## Errata 1 changes to the 2019 Nonresidential Compliance Manual

*This errata addresses twenty suggested revisions to the 2019 Nonresidential Compliance Manual (NRCM) along with minor changes to correct grammatical errors, clarify meaning, or generally clean up otherwise confusing language. Page numbers refer to the [2019 Nonresidential Compliance Manual](https://ww2.energy.ca.gov/publications/displayOneReport_cms.php?pubNum=CEC-400-2018-018-CMF) posted at [https://ww2.energy.ca.gov/publications/displayOneReport\\_cms.php?pubNum=CEC-400-2018-018-CMF](https://ww2.energy.ca.gov/publications/displayOneReport_cms.php?pubNum=CEC-400-2018-018-CMF). The text below shows changes in underline-strikeout. Added text is shown in underline; ~~deleted text shown in strikeout~~. This change document is not comprehensive and does not provide all of the minor changes (such as typos and formatting corrections) made that do not alter the meaning of the NRCM. The revised NRCM contains vertical change bars in the margins of each page to indicate a location where the manual has been altered.*

Figure 9-1: Orientation of Roof If Solar Zone Is Located on Steep-Sloped Roof

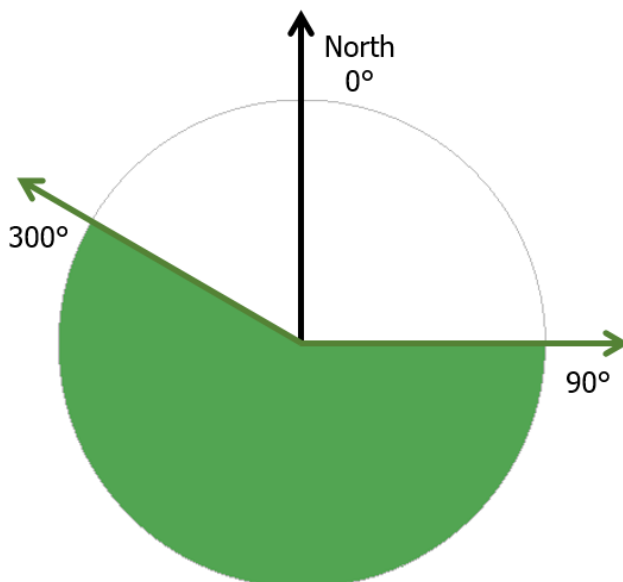
If the solar zone is ~~located~~ on a steep-sloped roofs (the roof has a rise to run ratio of greater than 2:12), then the roof must be oriented between ~~90-140~~ degrees and ~~300-270~~ degrees of true north (not magnetic north). The orientation is important because it ensures a reasonable solar exposure if a solar energy system is installed in the future.

#### Updated the figure

If solar zone is located on a sloped roof with a rise to run ratio greater than 2:12 (see above), then the roof must face between 90° and 300°
